Minor Material Amendment Statement

**BRIAN
O'REILLY
ARCHITECTS**

98 HIGHGATE WEST HILL
LONDON
N6 6NR

FIG. 1 & 2 showing photos received from number 97

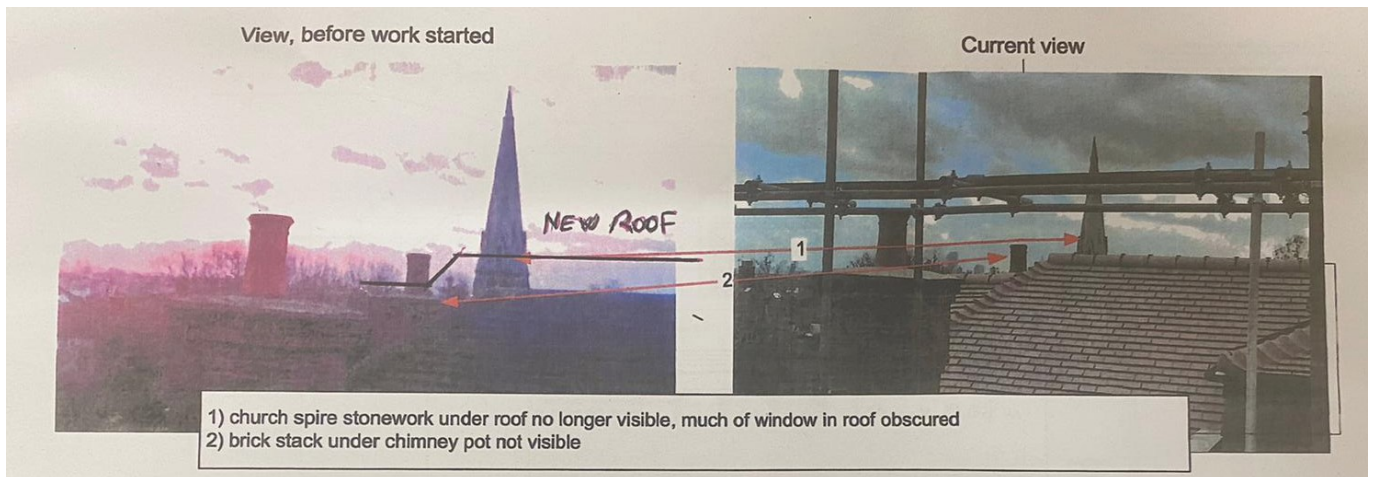
The pair of photographs below were provided by the neighbour at number 97. They are taken through a velux window on the south slope of their roof. The photo to the left (fig. 1) was taken before and the photo to the right was taken after (fig.2)

However, the photographs presented by the number 97 show the roof from 2 different perspectives. Their photos are misleading and this is evident by the relative position of the constant items (Chimney pots & spire).

We were given access to take our own photos from the same room and our superimposed image proves that their perspective assumptions are wrong — SEE FIG. 3

FIG. 3 photo montage showing overlay for direct comparison

FIG. 4 house survey from 2013 showing height of upper ridge is unchanged

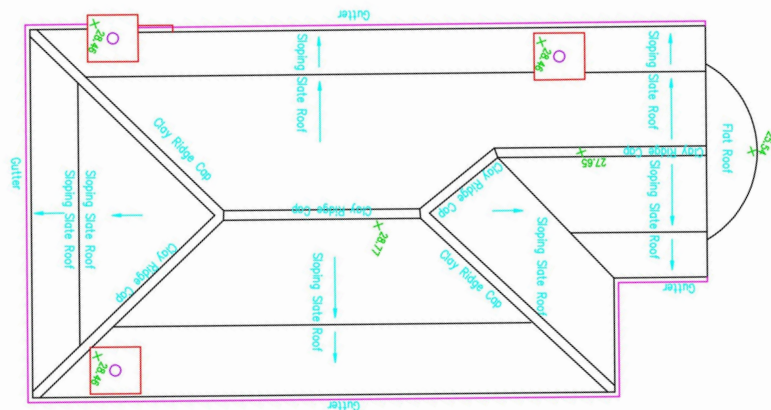
- our clients professional measured survey from 2013 shows spot levels including ridge levels. The upper ridge level is unchanged as built — *SEE FIG. 4*
Moreover another professional survey has been carried out in February 2020 after the works to the roof have finished, comparing the heights of the ridges from houses no. 96 to no. 100. The result is that the height of the ridge at no. 98 is under the average height of the ridges of the surveyed area. — *SEE FIG. 5*

The level distance between the upper roof ridge and the dormer roof matches the distance on the new survey below (note that both surveys have used different datums but dimensions calculate)

The upper ridge level on the plan is 28.77M and the level on the bay is 25.54= 3.23M

The as built ridge height is as the approved planning drawings and inline with the surveys.
